Determination 2007/23

Refusal of a code compliance certificate for a garage at 3 Oswald Crescent, Newlands, Wellington

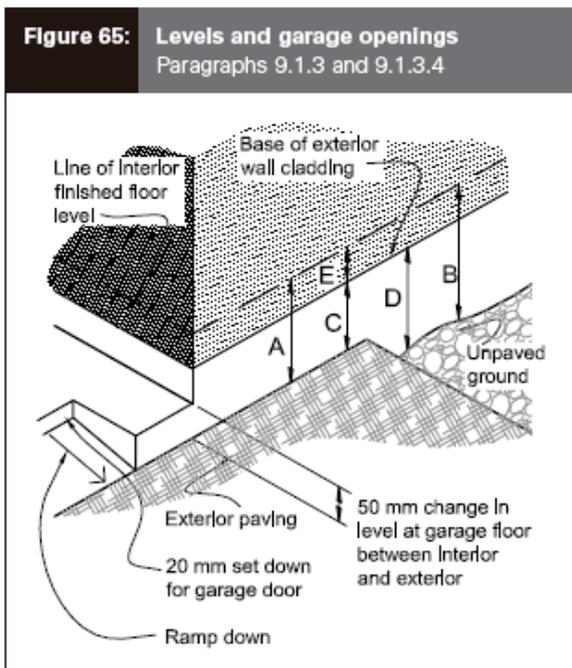
For the reasons set out in 6.1.5 and 6.1.6 below, I take paragraph 9.1.3.4 to refer to lined garages but not to unlined garages. For timber weatherboard cladding, Figure 65 and Table 18 require ground clearances of 100mm to paved surfaces.
